DRAINAGE INFORMATION SHEET

APPLICANT'S NAME: 410-416 San Pedro SE ZONE ATLAS/DRNG. FILE #: K18-D76

**RE: 410-416 SAN PEDRO SE (K18-D76). ENGINEER'S CERTIFICATIO FOR
CERTIFICATE OF OCCUPANCY APPROVAL. ENGINEER'S STAMP DATED
OCTOBER 11, 1999.**

DRAINAGE CERTIFICATION FOR LOT 23 & 24 @ 410-416 SAN PEDRO SE

GRADING/PAVING PLAN
410-416 SAN PEDRO SE

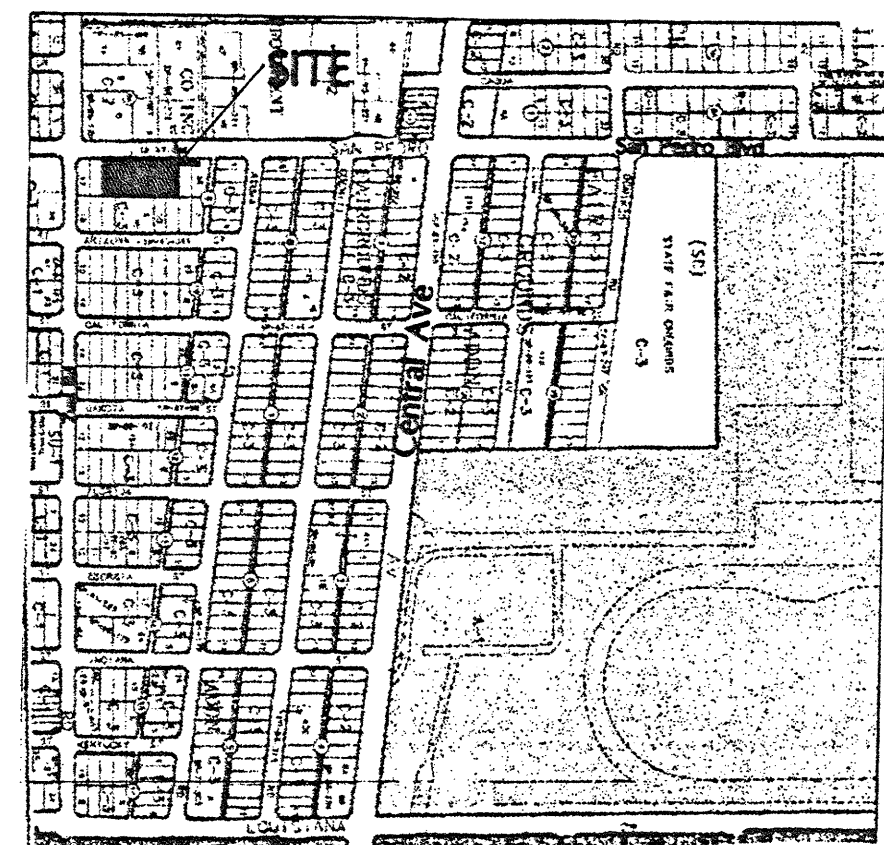
AS INDICATED BY THE AS-BUILT INFORMATION SHOWN HEREON: THE SITE AT 410-416 SAN PEDRO SE HAS BEEN GRADED AND DRAINED IN SUBSTANTIAL COMPLIANCE WITH THE APPROVED PLAN DATED 8/16/99 WITH THE FOLLOWING DEVIATION:

1. A TRASH ENCLOSURE WAS PLACED IN THE MIDDLE OF THE EAST PROPERTY LINE.

THE DEVIATION DOES NOT IMPACT THE DRAINAGE CONCEPT IN ANY WAY. THE SITE DRAINAGE WILL FUNCTION IN ACCORDANCE WITH PATTERNS ESTABLISHED BY THE APPROVED PLAN. THEREFORE, A PERMANENT CERTIFICATE OF OCCUPANCY IS HEREBY RECOMMENDED. THE AS-BUILT INFORMATION SHOWN HEREON WAS OBTAINED BY ME OR UNDER MY DIRECT SUPERVISION AND IS TRUE AND CORRECT TO THE BEST OF MY KNOWLEDGE AND BELIEF.

Based on the information provided on your October 27, 1999 submittal, the above referenced project is approved for Certificate of Occupancy.
